DRC-2009-007024

December 23, 2009

Re: White Mesa Uranium Mill – First Round of Interrogatories From Review of License Amendment Request and Environmental Report For Cell 4B

FIGURE 2.4.1-1
Reclamation Cover Grading Plan
for Cell 4B

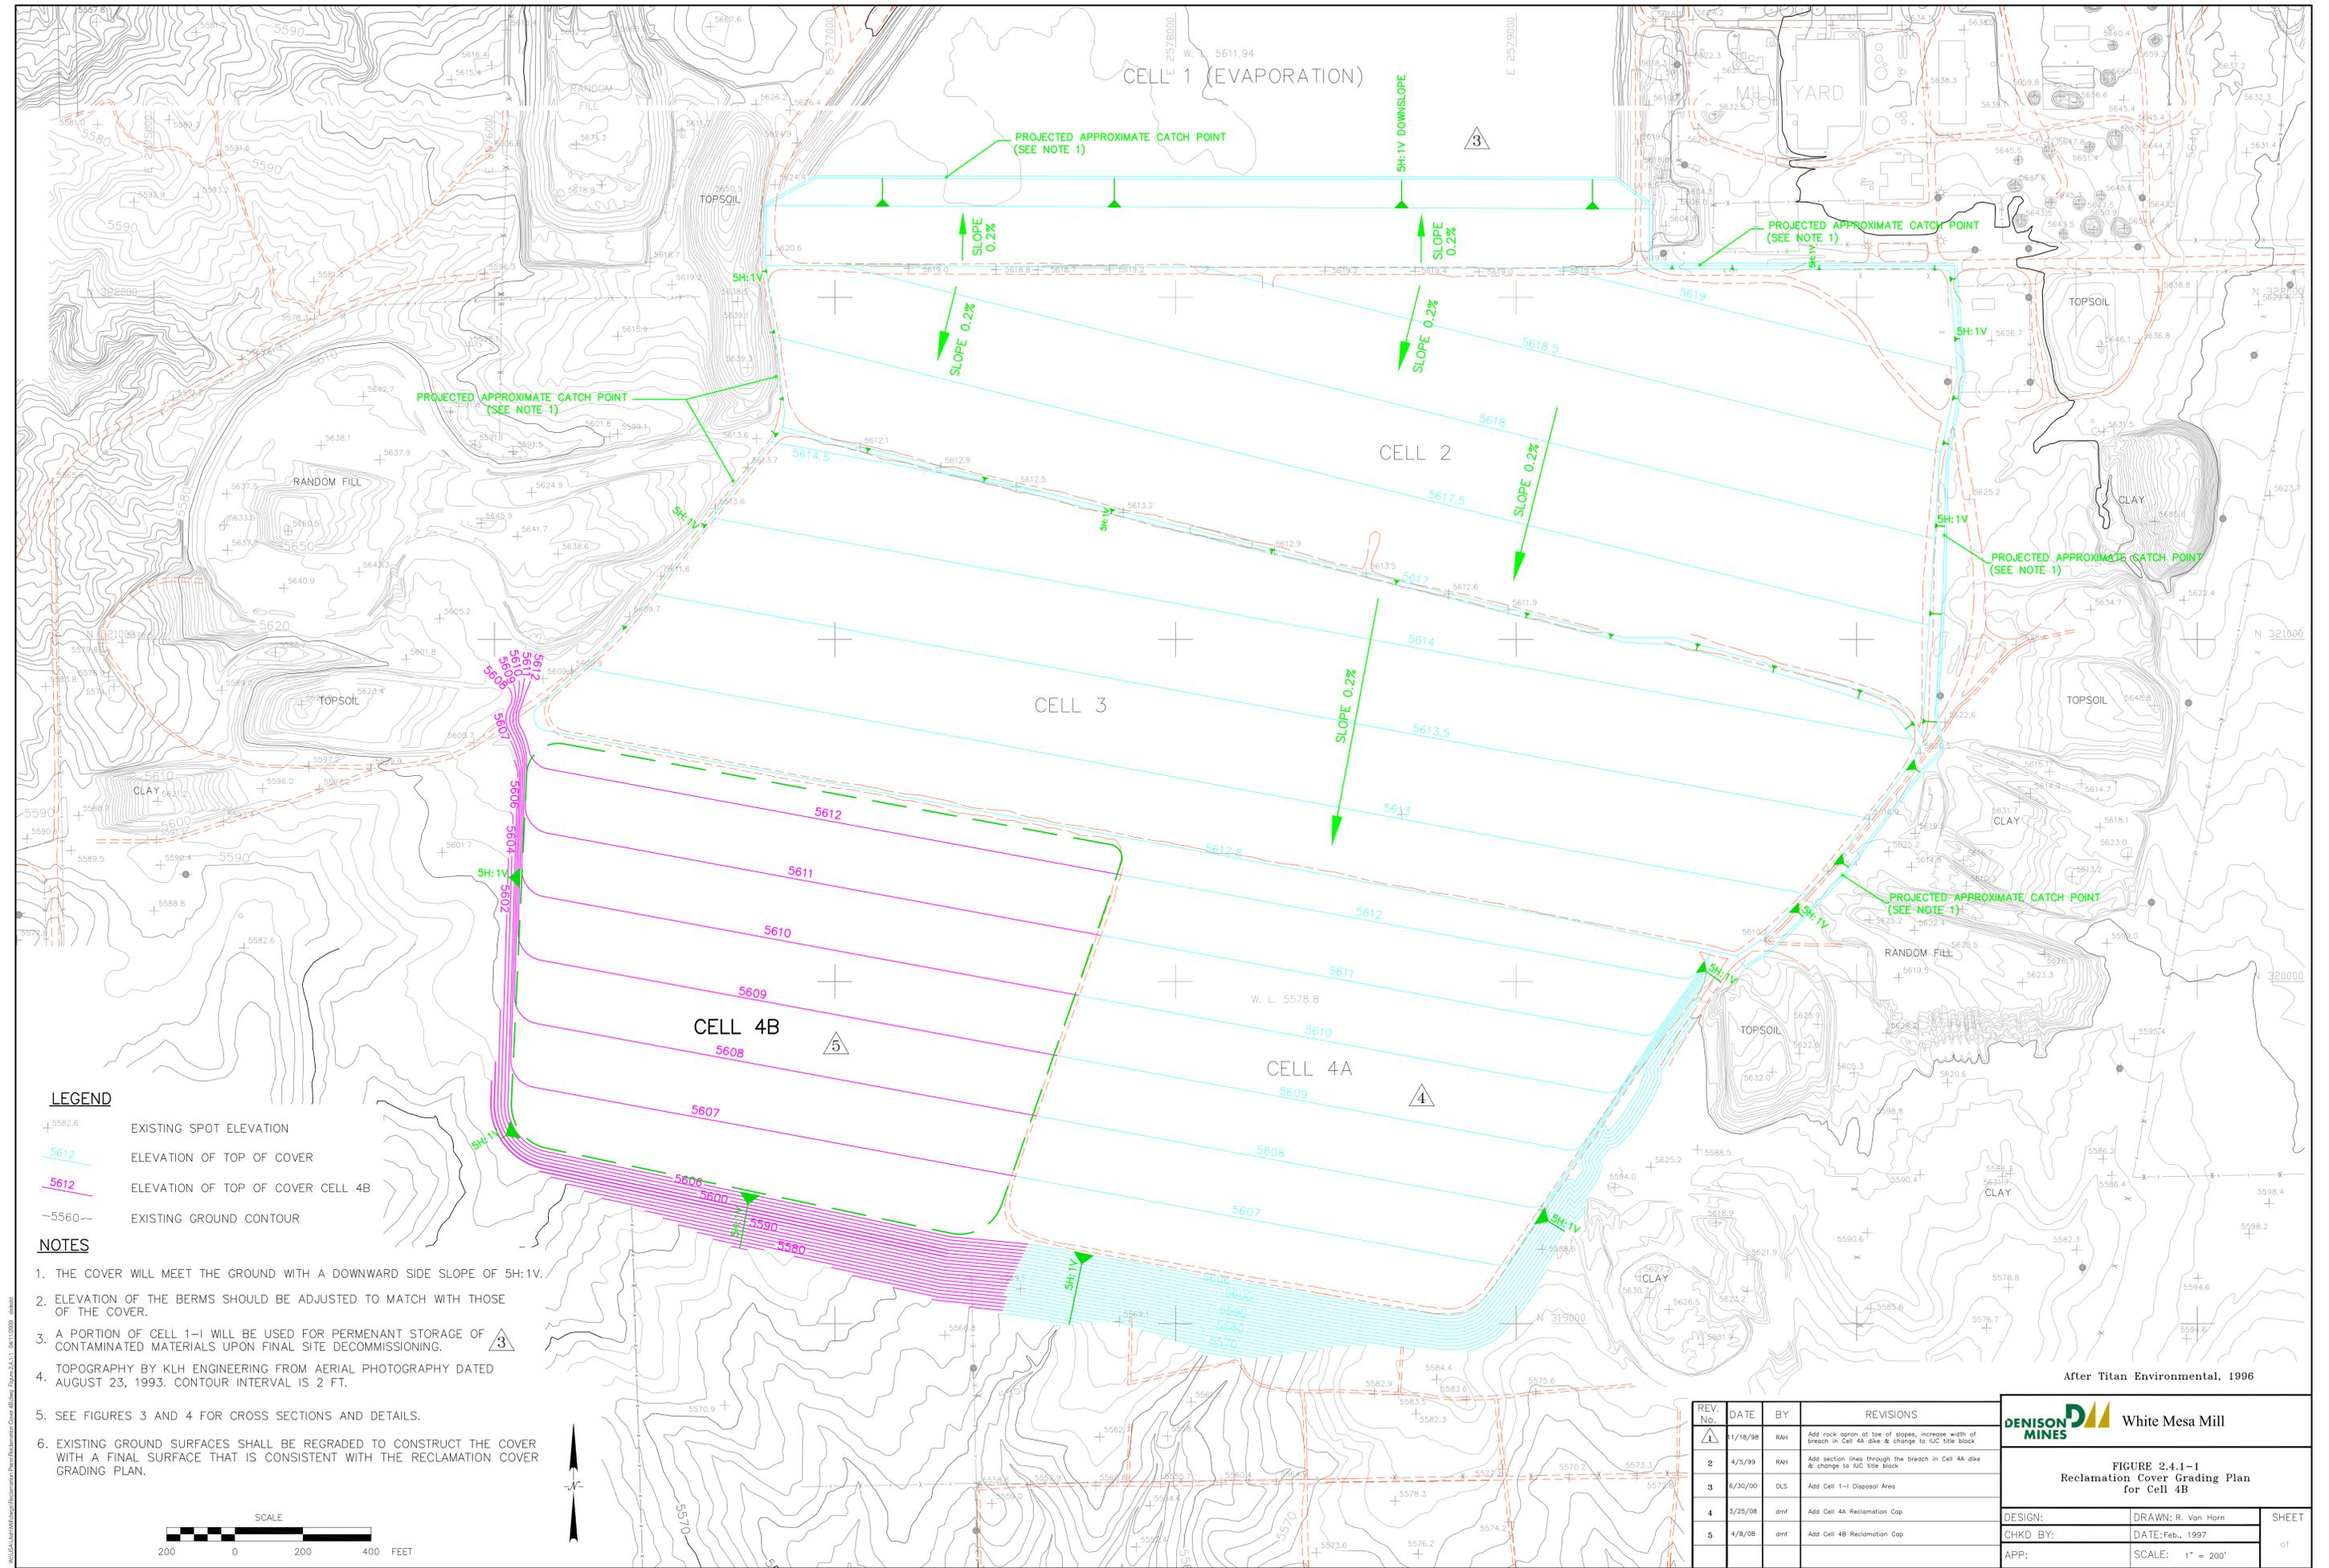
2.4.1 Please provide an updated Reclamation Plan that considers the current concept of fully utilizing Cells 4A and 4B for tailings management, including the long term stabilization and disposal of tailings. The updated Reclamation Plan must account for the use of these two cells for disposal, which will directly impact the length of slopes, precipitation runoff rates and volumes, design of the top cap, and design of the cap side slopes including rock sizing and fill depth.

The Reclamation Plan, Rev. 4.0, was submitted to DRC on November 23, 2009. The Reclamation Plan, Rev. 4.0 presents the plan for reclamation of the site as it exists today, prior to the construction of Cell 4B. The Reclamation Plan will be further revised to incorporate the addition of Cell 4B prior to acceptance and authorization for use by DRC. Figure 2.4.1-1 presents the concept for final reclamation of Cell 4B. As one of several conditions to the GWDP, an infiltration analysis of the tailings cover and re-design of the cover for better performance is in progress. The final revised cover design will address surface water management issues associated with the addition of Cell 4B.
